**RE: Gold Hill Mill; DRMS File No. M-1994-117: Adequacy Review No. 1 (AM 01)**

This is the Colorado Milling Company, LLC's Response Letter to the Michael Cunningham's Adequacy Review of the Application for an Amendment to the Gold Hill Mill Limited Impact 110 (2) Permit No. M-1994-117, to formally add the previously permitted Left Hand Creek Pump Station, Gold Hill Mill Pipeline, and the Times Mine adit portal to the affected land boundary of the Gold Hill Mill Permit. These three features are collectively referred to as the Gold Hill Mill Waterline in this Response Letter. In order to ensure that the responses to the Division of Reclamation, Mining and Safety's request for additional information and clarification can be properly reviewed, the responses are set out below each of Michael Cunningham's Adequacy Review comments. A separate cover letter for each of the responses that require additional material is attached to this Response Letter.

COLORADO MILLING CO.-PERMIT NO. N-1994-117-LOCATION MAP-GOLD HILL QUAD  
LOCATED IN SECTIONS 2, 11, 12 T-1-N, R-72-W OF THE SIXTH P.M.,  
COUNTY OF BOULDER, STATE OF COLORADO

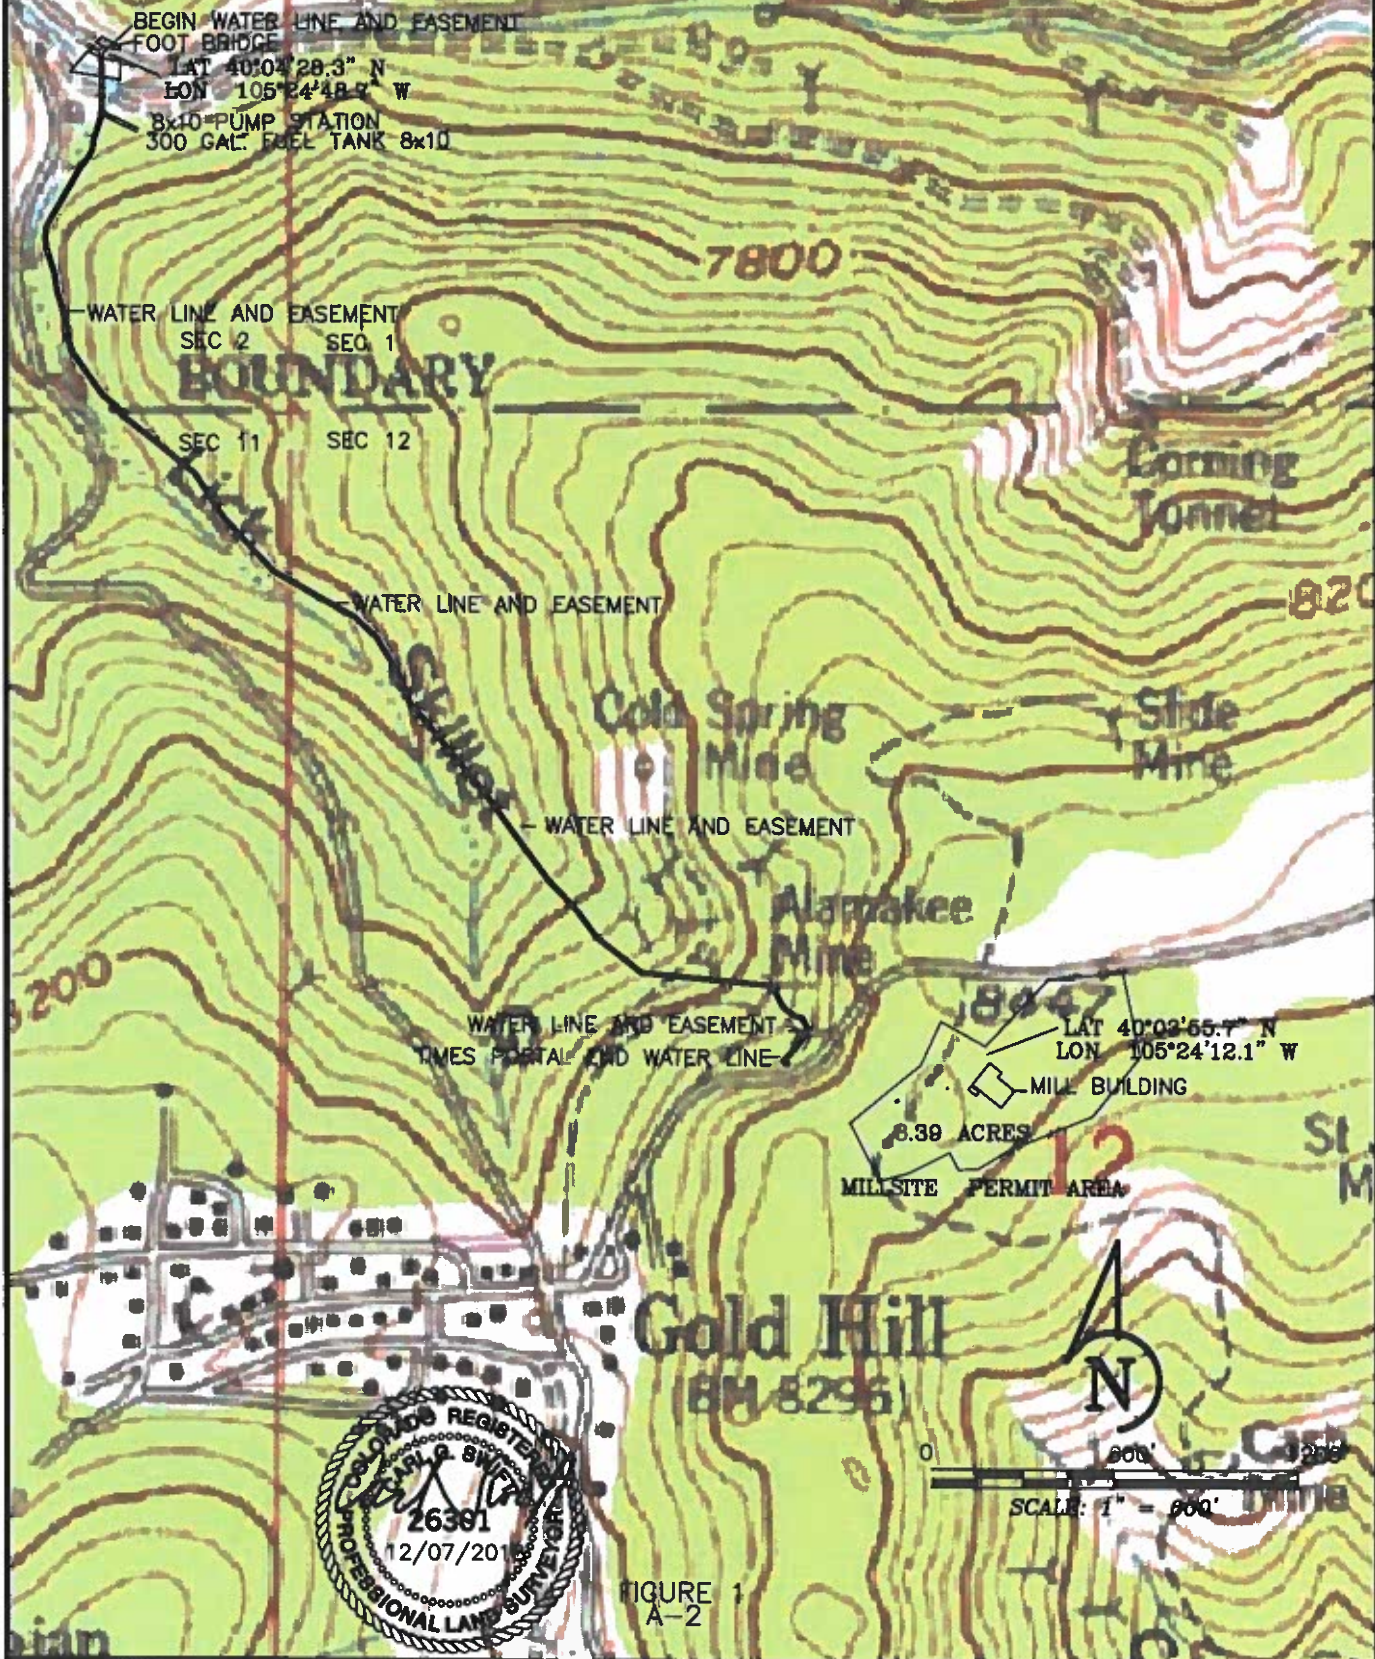
7. Pursuant to Rule 6.3.1(2), the latitude and longitude coordinates of the main entrance to the mine must be labeled. Please revise the Location Map to include the coordinates of the mine entrance.

**CMC Response:** The Location Map has been revised to include the coordinates of the entrance to the Gold Hill Mill. These are the coordinates for the entrance gate into the Gold Hill Millsite: Latitude 40 Degrees 03 Minutes 55.7 Seconds North; Longitude 105 Degrees 24 Minutes 12.1 Seconds West.

**E-1 MINE PLAN - COLORADO MILLING CO.-GOLD HILL MILL WATERLINE  
LOCATED IN SECTIONS 2/11/12, T-1-N, R-72-W OF THE SIXTH P.M.,  
COUNTY OF BOULDER, STATE OF COLORADO**

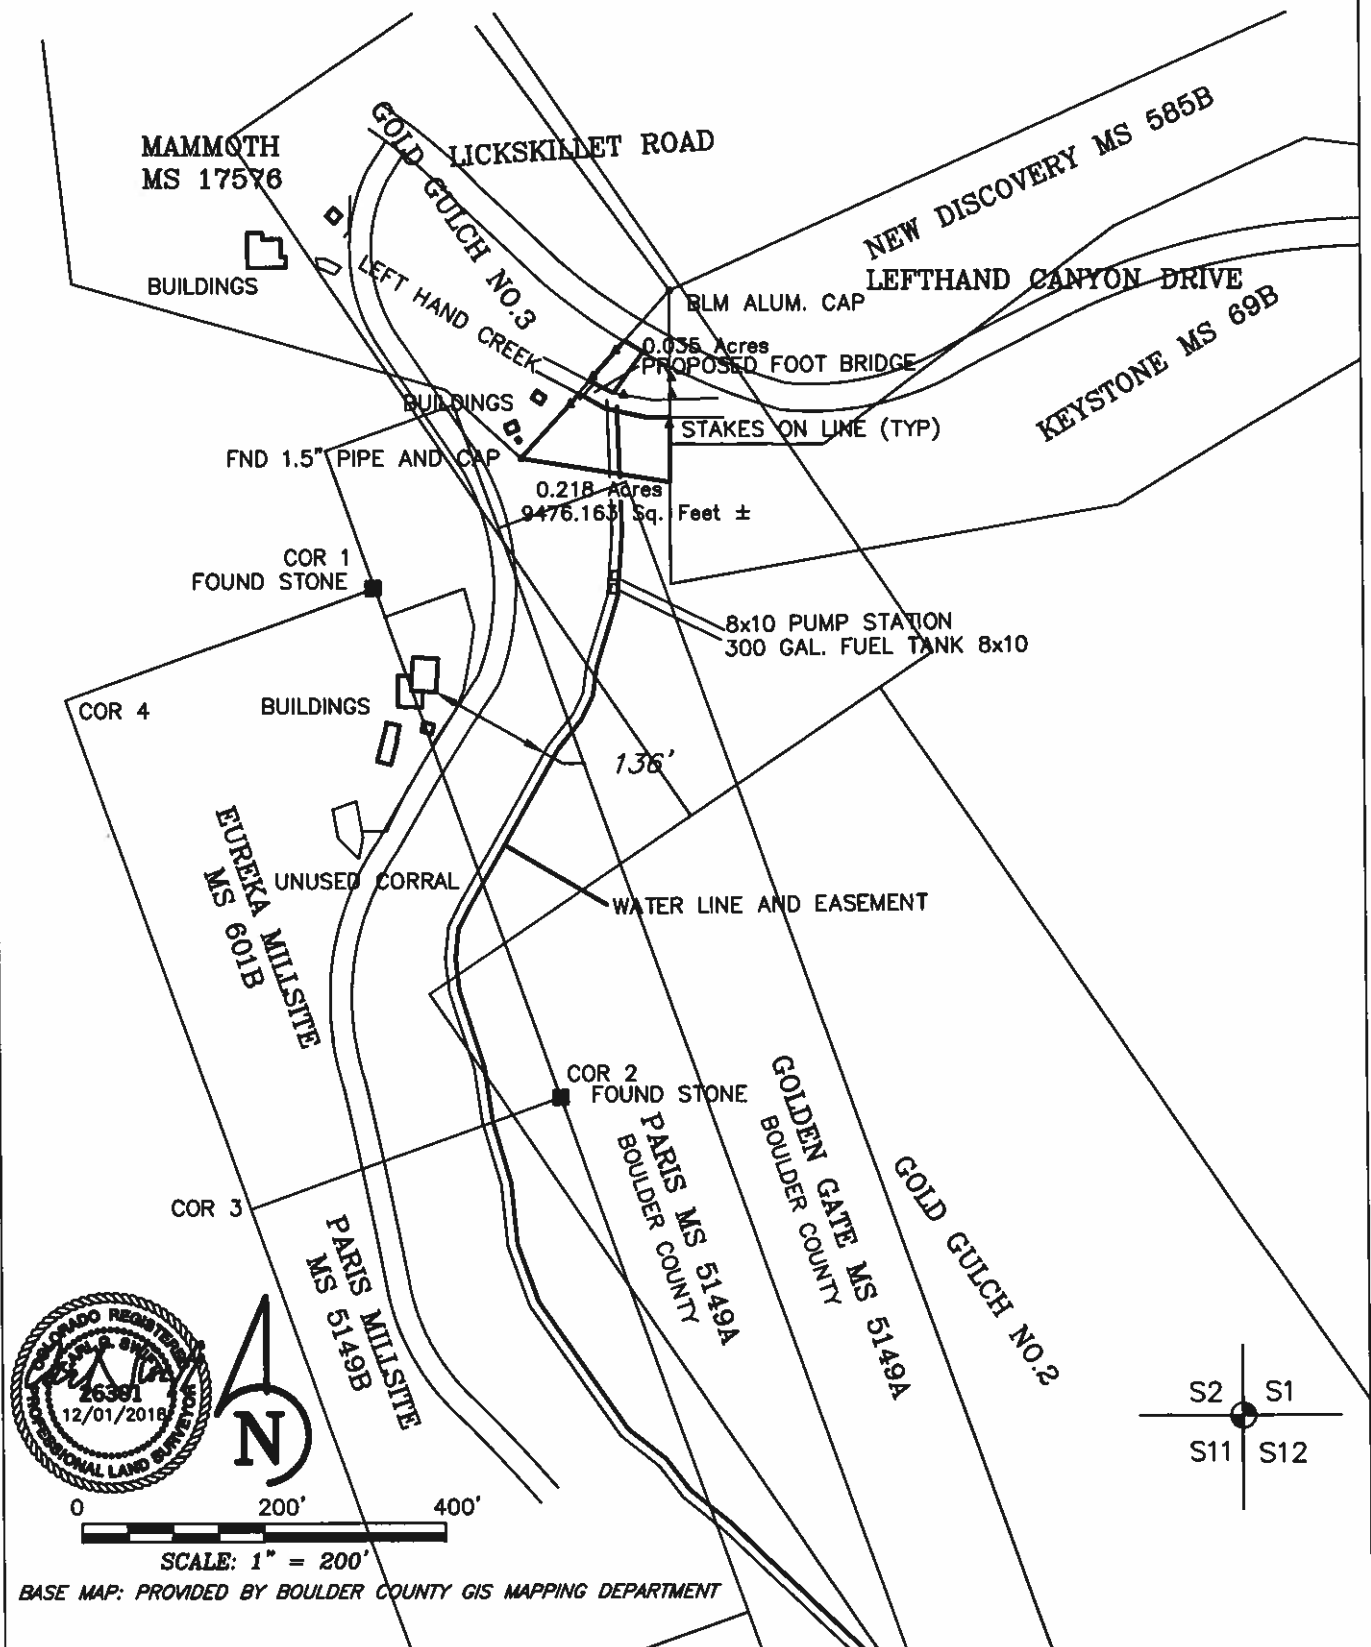
13. [Duplicate number 13] Identify where the check valves and anti-siphon valves will be installed by labeling these features on a revised Mining Plan Map.

36. As required by Rule 6.3.5(2)(c), the Mining Plan Map must note the location of any permanent man-made structures within 200 feet of the affected area. Please ensure the structures on the Mining Plan Map can be correlated with the description of the structure owners in Exhibit B.

37. The Mining Plan Map does not depict the proposed footbridge. Please revise the Mining Plan Map to include an outline and label for the footbridge.

**CMC Response:** There will be five (5) check valves placed along the length of the Pipeline. These will be located every one-thousand (1000) feet along the length of the Pipeline. An anti-siphon valve will be installed in the two (2) inch HDPE pipeline inside the Times Mine adit to relieve air pressure when the Bean pump is pushing the water column up from Left Hand Creek. A check valve has already been installed inside the Times Mine adit to prevent water flowing from behind the bulkhead in the future. Four of these five (5) check valves are identified on Map E-1 Mine Plan and on Map E-2 Gold Hill Mill Waterline Map attached to the Response Letter. The fifth check valve is located inside the Times Mine adit.

**CMC Response:** The Mining Plan Map has been revised to show the location of any permanent man-made structures within 200 feet of the affected area. All of the structures on the Mining Plan Map can be correlated with the description of the structure owners on Exhibit B.

**CMC Response:** The Mining Plan Map has been revised to depict the proposed footbridge with an outline and label for the footbridge.

**E-2 SURFACE OWNERSHIP & PERMIT AREA  
COLORADO MILLING CO. - GOLD HILL MILL WATERLINE  
LOCATED IN SECTIONS 2/11/12, T-1-N, R-72-W OF THE SIXTH P.M.,  
COUNTY OF BOULDER, STATE OF COLORADO**

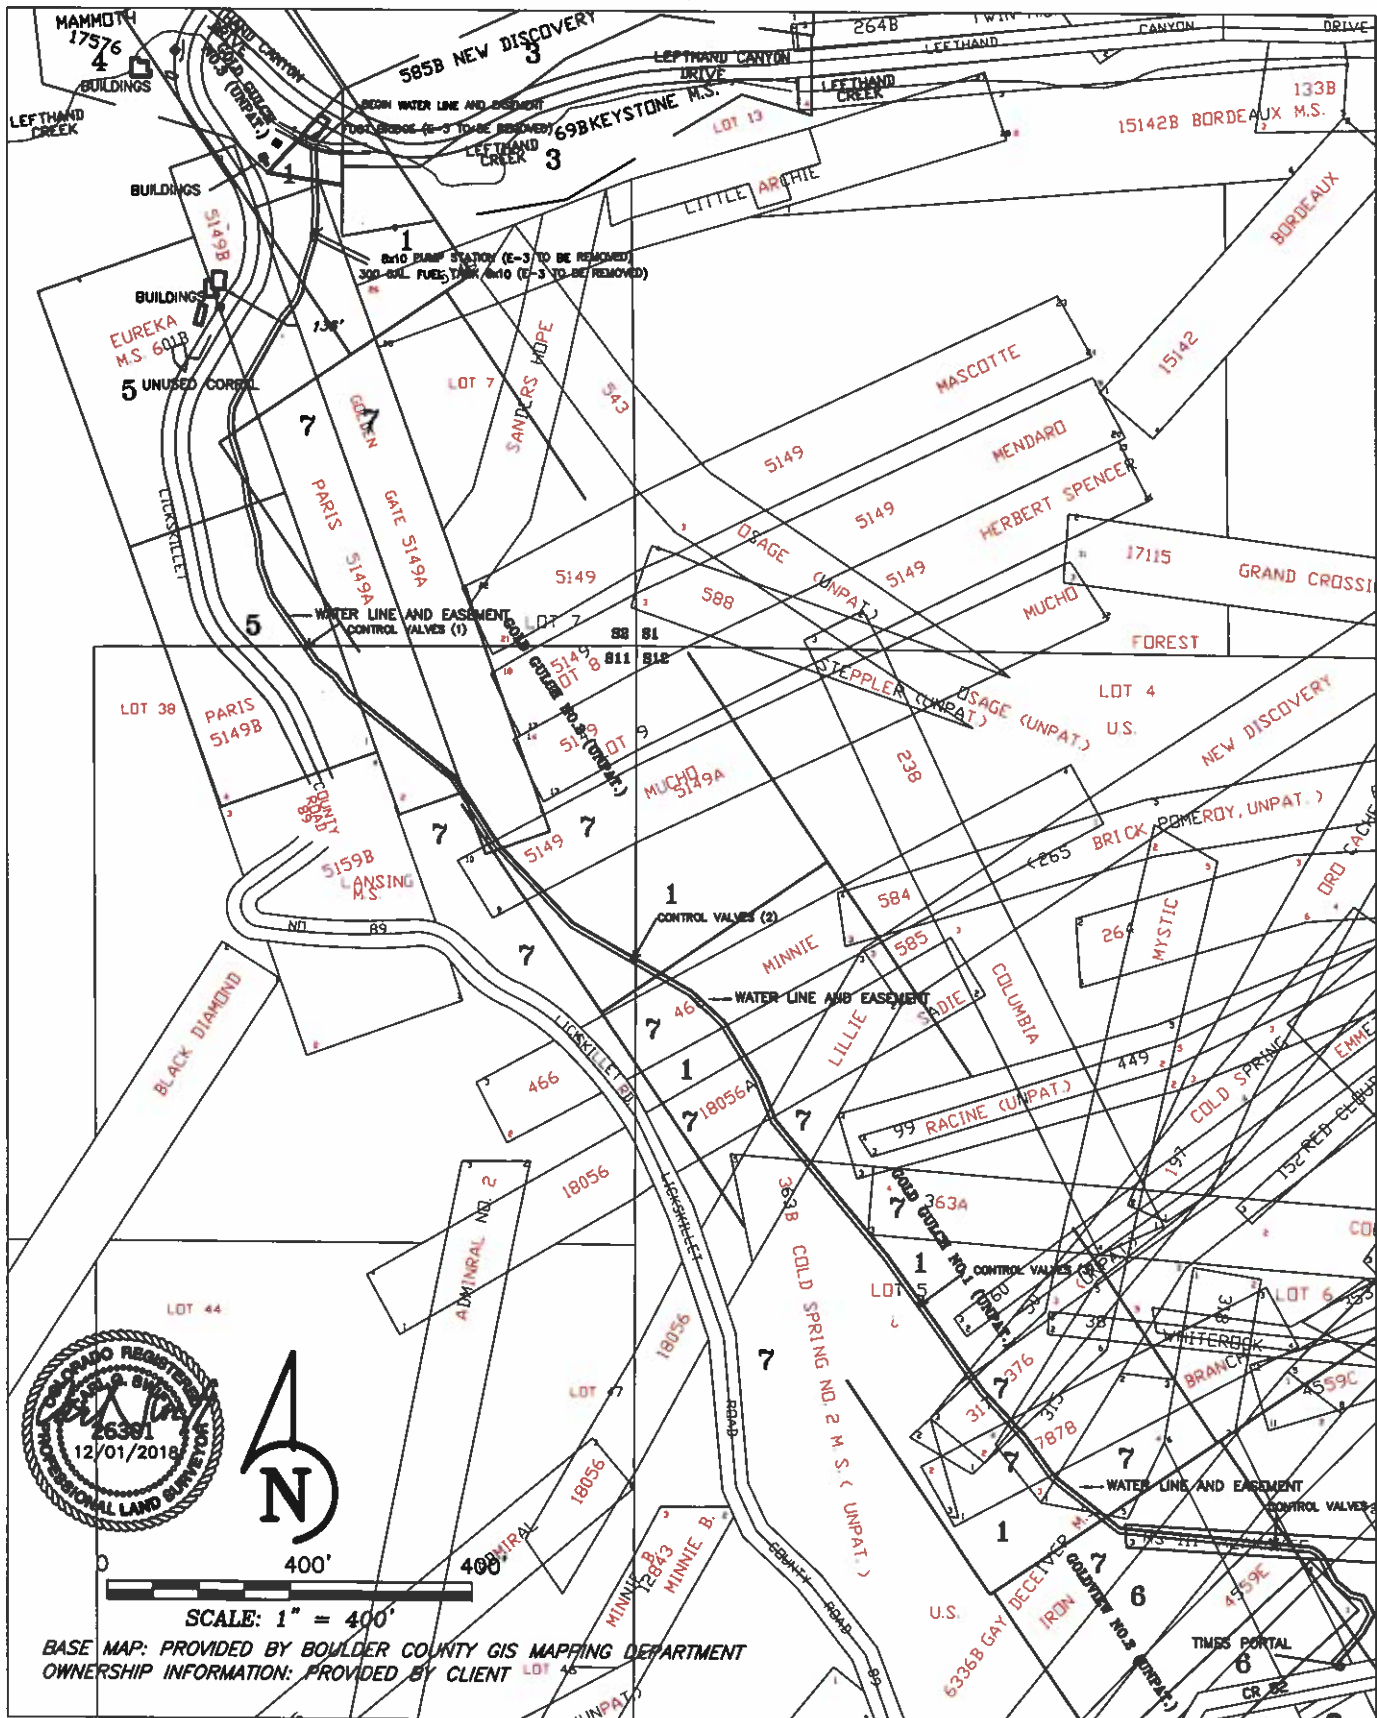
8. Pursuant to Rule 6.3.1(3), the Location Map must show the names of all immediately adjacent surface owners of record. Please revise the Location Map to show the names of all immediately adjacent surface owners for the entire affected area of the Gold Hill Mill operation. In addition, the Location Map must contain a label with the mine site name.

**CMC Response:** Map E-2, Surface Ownership & Permit Area has been revised to show the names of all immediately adjacent surface owners of record for the area affected by the inclusion of the Gold Hill Mill Permit boundary. These are shown on Map E-4, Surface Ownership and Permit Area for the entire area affected by the Gold Hill Mill operation.

**E-3 MINE RECLAMATION PLAN  
COLORADO MILLING CO.- GOLD HILL MILL WATERLINE  
LOCATED IN SECTIONS 2/11/12, T-1-N, R-72-W OF THE SIXTH P.M.,  
COUNTY OF BOULDER, STATE OF COLORADO**

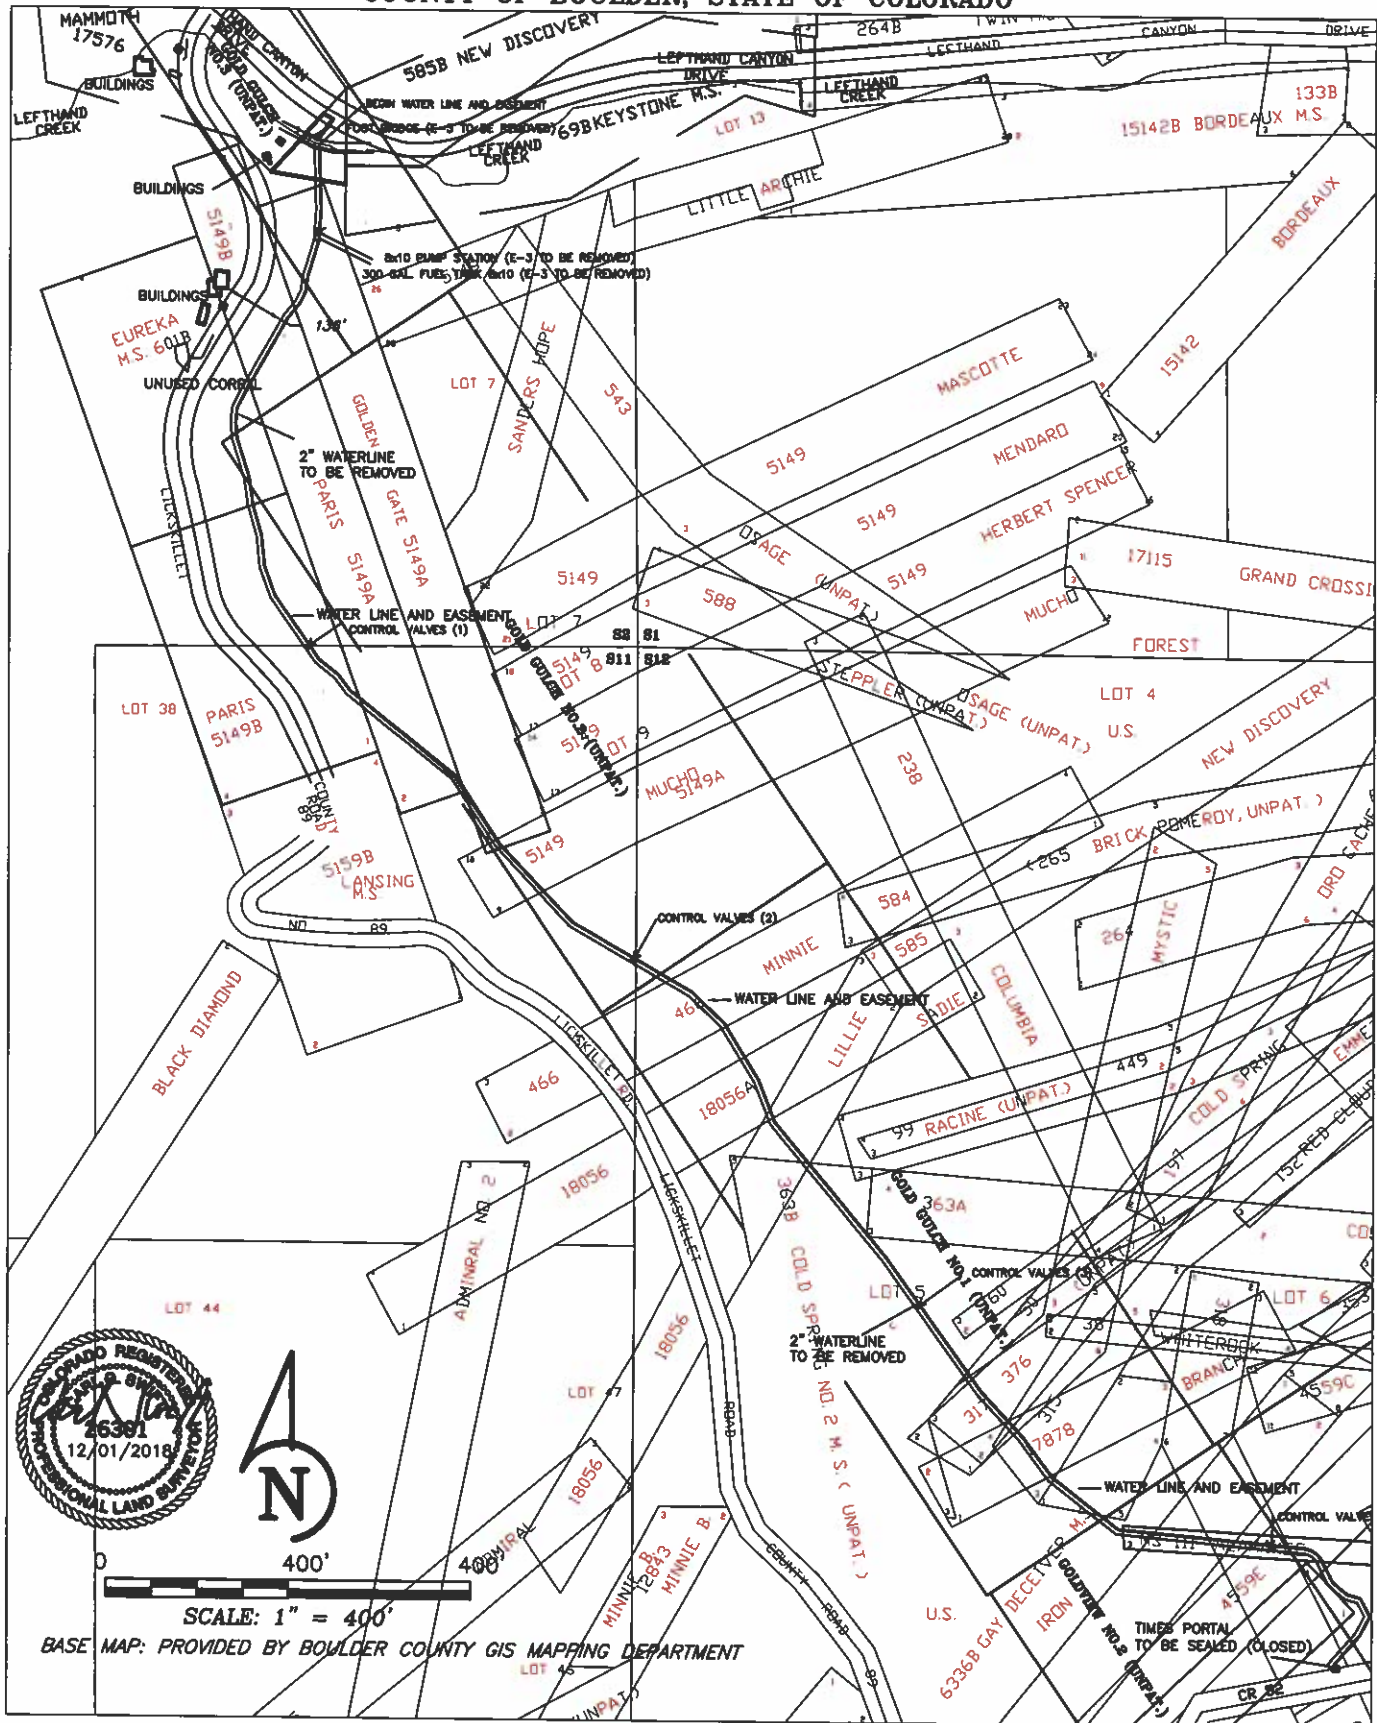
35. The Mining Plan and Reclamation Plan Maps only depict the affected area of 0.797 acres which are being added through the Amendment Application. Please revise both maps so the entire affected area of the Gold Hill Mill operation is depicted.

**CMC Response:** The Mining Plan and Reclamation Plan Maps have been revised so that the entire area of the Gold Hill Mill operation is depicted. The addition of the Gold Hill Mill Waterline to the affected land boundary of the Gold Hill Mill will increase the total permitted acreage to 9.187 acres.
